SPANWISE BEAM # 3

CW-607

Z-2506

SPANWISE BEAM # 3 STIFFENER

CW-607
 Z-2506
 GREEN TAG

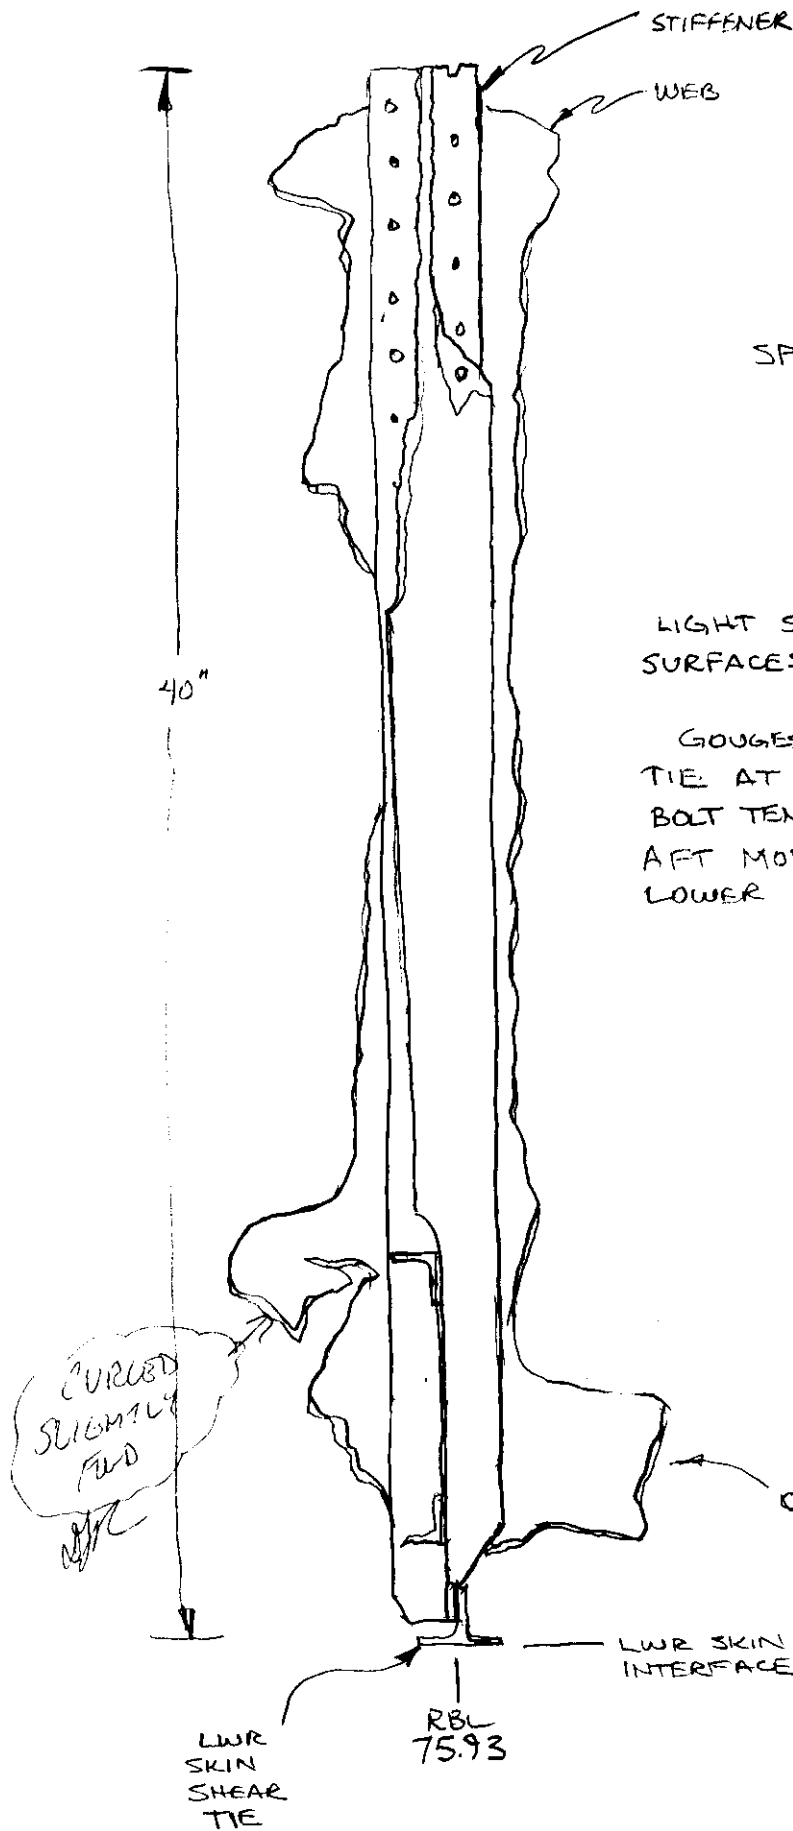
This item is the lower 40" of the RBL 75.90 stiffener with a width of 4" to 11" of web attached for its entire length. The lower end has the shear tie intact. The web is torn and slightly bent both fwd and aft.

~~No fire damage or sooting is observed.~~

LIGHT SOOT PREDOMINANTLY ON AFT SURFACES (SIMILAR TO CW602)

GOUGES IN LWR SURFACE OF SHEAR TIE AT LWR SKIN INTERFACE INDICATES BOLT TENSION FAILURE WITH SUBSEQUENT AFT MOVEMENT RELATIVE TO THE LOWER PANEL

CURLED SLIGHTLY FWD

CURLED SLIGHTLY AFT
